City of Portland, Maine – Building or Use Permit Application 389 Congress Street, 04101, Tel: (207) 874-8703, FAX: 874-8716

Permit No: **950519**

| Location of Construction: 1011 & 1013 Washington 1009 - 1013 Washington Ave | | Owner: Jandie Development Corp. | | Phone: 797-0713 | <div style="border: 2px solid black; padding: 5px; text-align: center;"> PERMIT ISSUED Permit Issued: MAY 25 1995 CITY OF PORTLAND </div> | |
| Proposed Project Description: Construct Duplex as per plans | | PEDESTRIAN ACTIVITIES DISTRICT (P.A.D.) Action: Approved <input type="checkbox"/> Approved with Conditions: <input type="checkbox"/> Denied: <input type="checkbox"/> Signature: Date: | | Zoning Appeal <input type="checkbox"/> Variance <input type="checkbox"/> Miscellaneous <input type="checkbox"/> Conditional Use <input type="checkbox"/> Interpretation <input type="checkbox"/> Approved <input type="checkbox"/> Denied | | |

SECTION THRU MAIN
SCALE: 1/2" = 1'

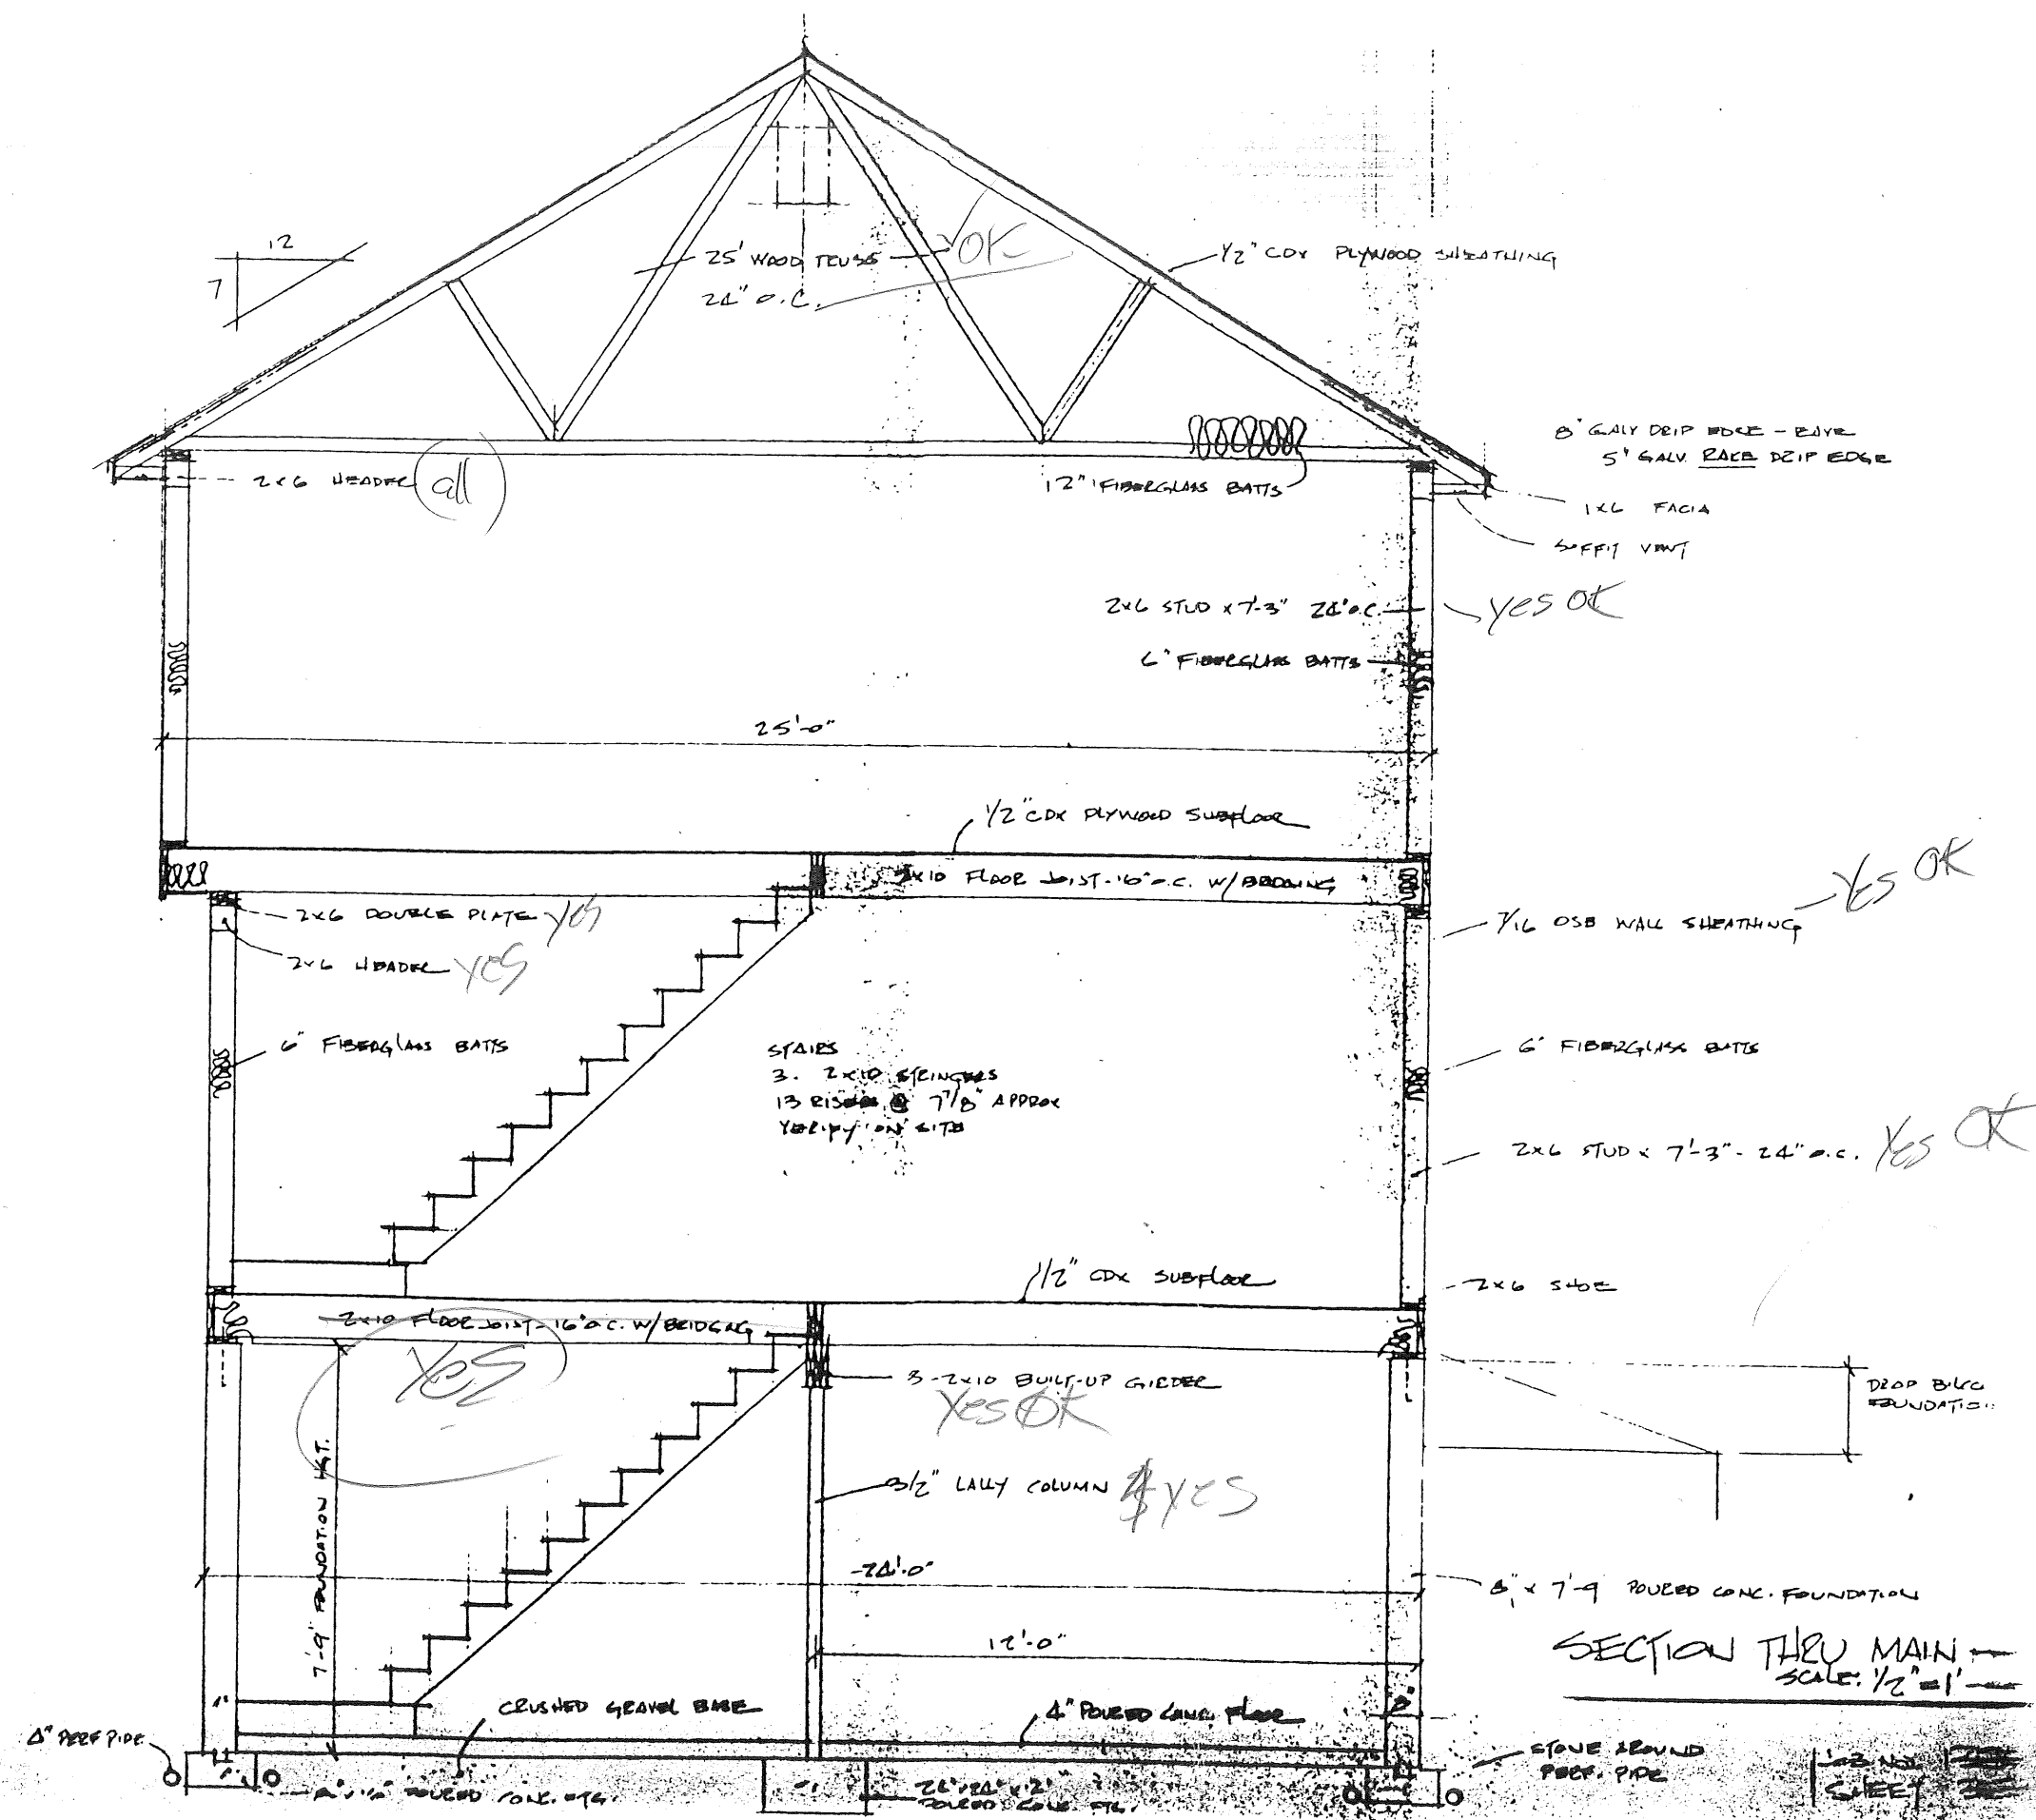
Your applications to construct a 26' x 36' duplex dwelling has been reviewed and a permit is herewith issued subject to the following requirements: This permit does not excuse the applicant from meeting applicable State and Federal laws.

1. Please read and implement items 1, 7, 9, 11, 13, 14, 15 and 16 of the attached building permit report.
2. Dwelling unit separation shall have a fire resistance rating of (1) one hour - this assembly shall be continuity as per Chapter 7, Section 709, Subsection 4 which states: "All vertical fire separation assembly shall extend from the top of the fire resistance rated floor/ceiling assembly below to the underside of the floor or roof slab or deck above and shall be securely attached thereto. These walls shall be continuous through all concealed spaces such as the space above a suspended ceiling. All hollow vertical spaces shall be firestopped at every floor level as required in Section 720.0 of the City's building code.
